Staff Report & Recommendation

PLANNING BOARD

SUBJECT:

PB20-0402. 880 71st Street.

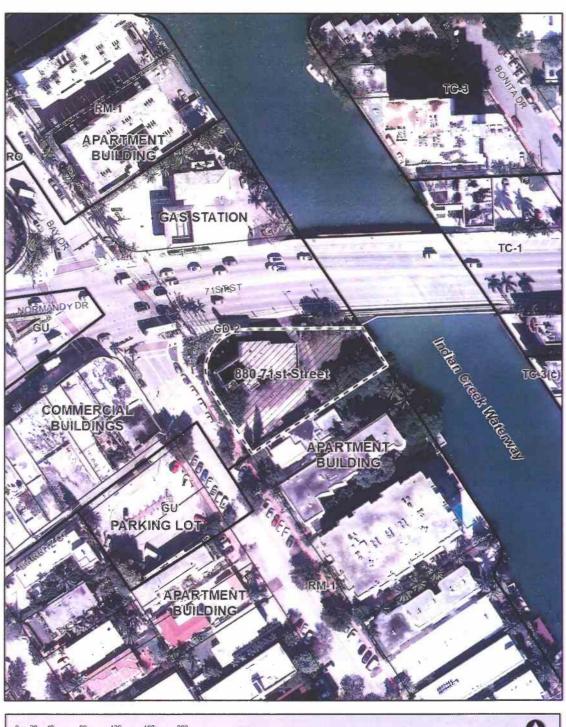
The loading of refuse will take place in the open-air loading spaces. Loading would be limited to 20-foot trucks. Loading for larger trucks would be accommodated the parking area, though it may block the use of some of the parking spaces.

The applicant has not provided limits for hours in which loading and refuse collection will take place. Staff would recommend that refuse collection and loading take place between 9:00 AM and 4:00 PM to minimize traffic impacts during the busy evening rush hour and limit noise concerns in the adjacent residential areas.

- c. Deliveries and trash collection shall take place only at the designated areas proposed by the applicant as shown in the plans.
 - d. Deliveries or trash pick-up shall only be permitted between 9:00 AM and 4:00 PM.
